TOWN OF PLYMOUTH
Department of Public Works
Engineering Division
26 Court Street
Plymouth, Massachusetts 02360

MEMO

Ref: LWP Plymouth, LLC– Case No 3970
Colony Place
Parcel ID 104-000-026-029

**RE: The Walk at Colony Place Development, Plymouth, Massachusetts
Supplemental Water System Analyses**

Figure 1: Northern Zone Firm Capacity

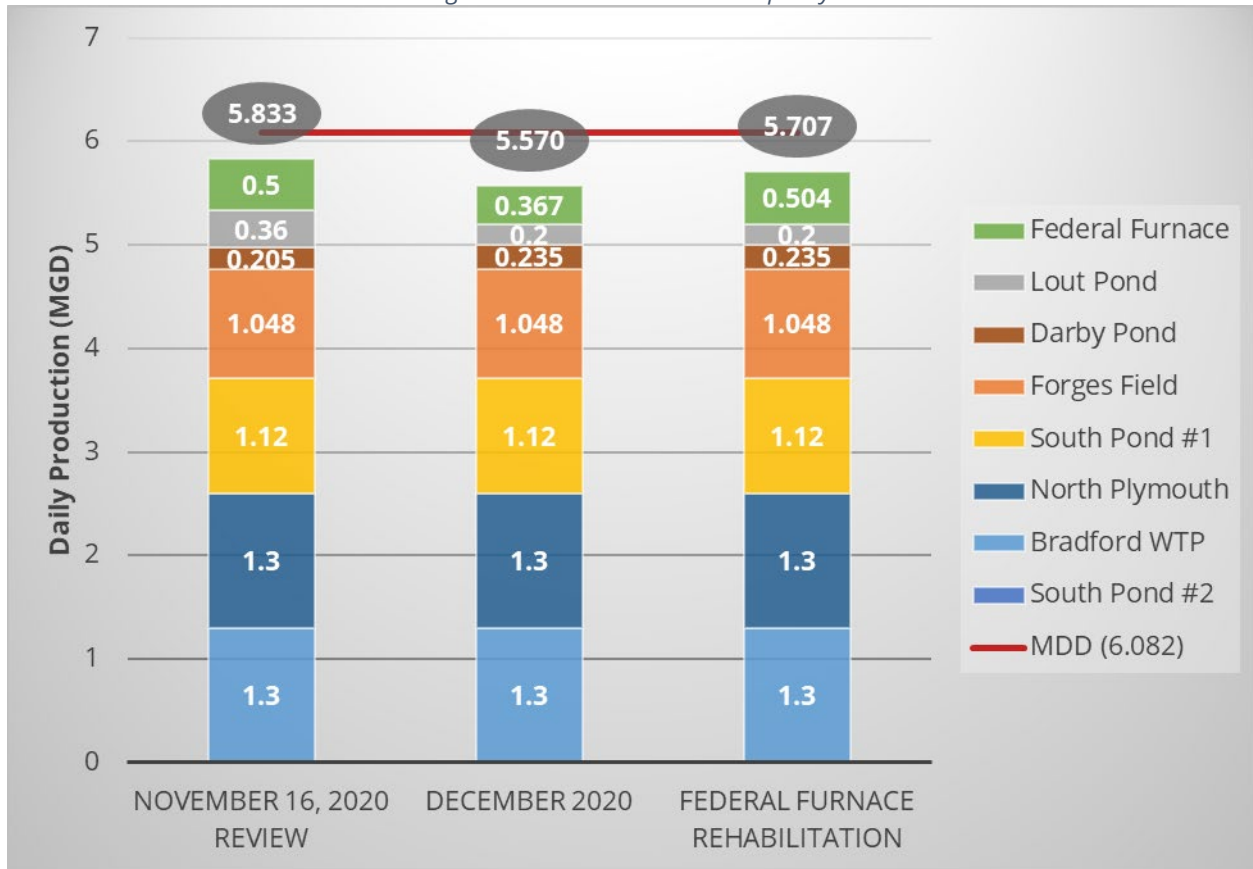
Based on a review of the information presented in Figure 1, the northern pressure zones do not have the firm capacity to meet maximum-day demands.

EP Response 12/28/2020: As depicted in Figure 1 above, the firm capacity calculations incorporate the supply from Forges Field Well and continue to show a deficit when compared to the maximum day demand.

Figure 2: Monthly System Demands & Northern Zone Firm Capacity

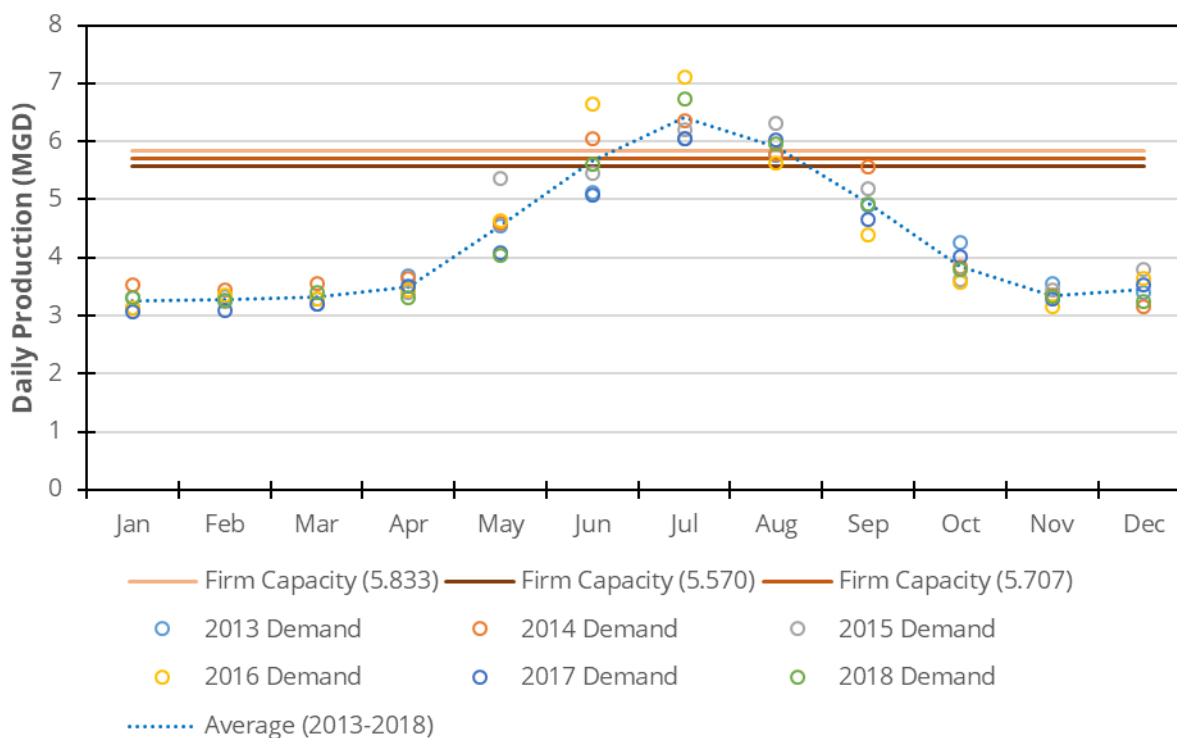
While demands are relatively low for most of the year, average monthly system demands often exceed approximately 6 MGD in June, July, and August. Since Darby Pond restrictions often go into effect in the late summer as discussed above, August and early September are the times of year when the water system is most at risk of a supply shortfall.

We also note that the Town has observed the potential effects of implementing a water ban on system demands during a drought. As illustrated in Figure 2, June and July 2016 demands were higher than other recent years prior to the implementation of a water ban. After implementing a strict water ban, the Town observed below average water demands in the subsequent months. Water bans are unpopular, and it can be difficult to predict exact reductions in demands. However, if the Town is willing to implement water bans and can achieve a similar level of demand reduction in a future water ban, it may be possible to overcome short-term summertime supply issues.

Figure 3: Northern Zone Supply Capacity during Loss of Supply Scenarios

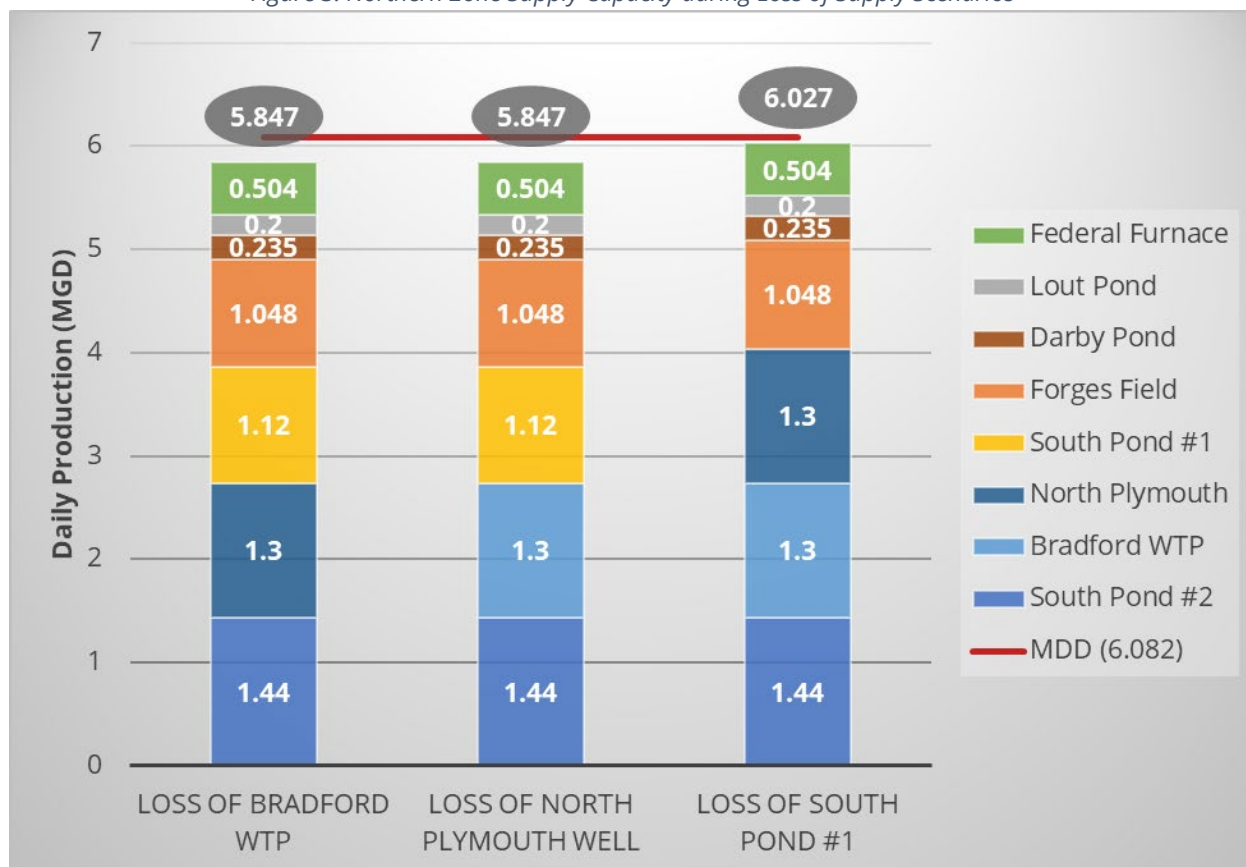
EP Response 12/28/2020: As discussed in the Firm Capacity section above, the firm capacity calculation is standard practice for a water utility. Regardless, the problem is more acute than simply the loss of the largest source, South Pond Well #2. In fact, as illustrated in Figure 3 below, the loss of any one of the Town's next three largest sources (Bradford Water Treatment Plant, North Plymouth Well, or South Pond Well #1) would result in a water supply deficit. Furthermore, if the Federal Furnace Well pump upgrades are not as successful as hoped, it is possible that the loss of Forges Field Well could also lead to a supply deficit.

In addition, as discussed in other portions of this letter, Darby Pond Well restrictions are typically in effect by mid- to late summer when system demands are high. Therefore, it is reasonable to assume that Darby Pond Well can only provide 0.235 MGD during critical demand periods.
